Notice of Decision

Tentative Partition Plat, Site Plan Review for Tree Felling, and Site Plan Review for New Construction

PA-05-24; SP-08-24; & SP-09-24

May 28, 2024

EXISTING CONDITIONS/DEMO PLAN
 DATE: FEBRUARY 22, 2024
 DRAWN BY: 23 2023 LERNAN GEAFF STREET
 CHECKED BY: BRYAN MCKAY

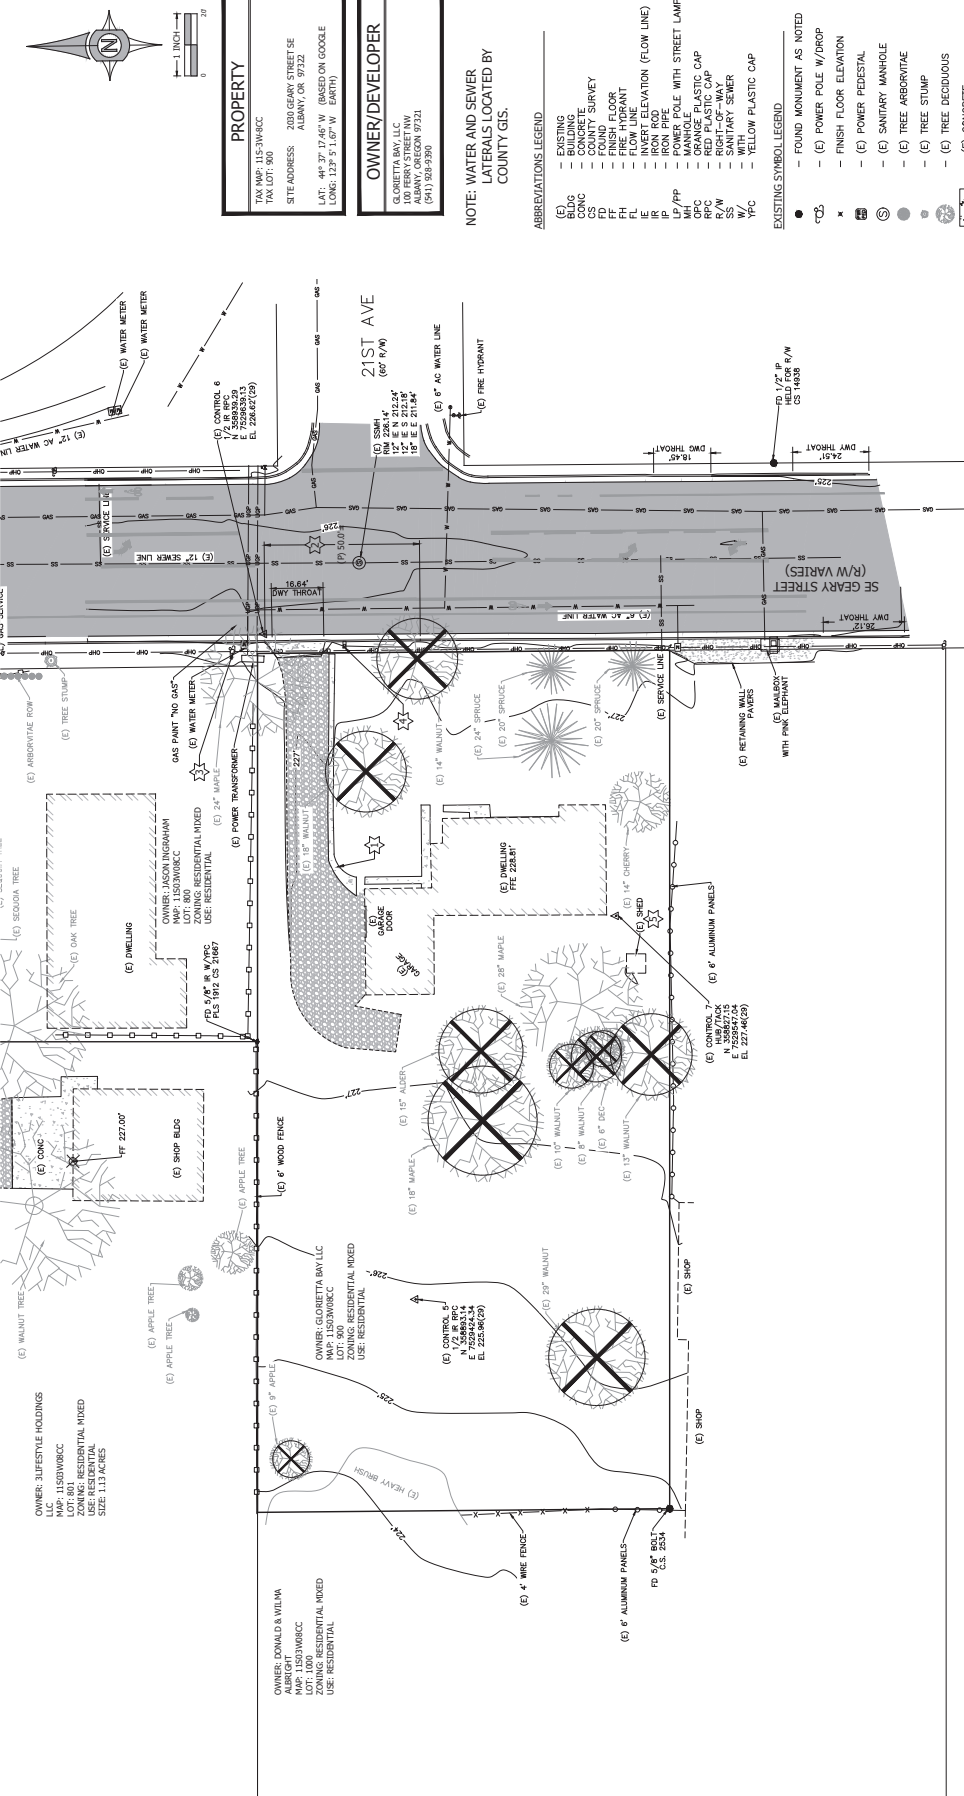
- Condition 7** In the event the proposed development does not take place, the identified trees for removal on the Existing Conditions Plan (Attachment B.1) shall not be removed without separate approval for tree felling not associated with development, using criteria listed in ADC 9.205(3).
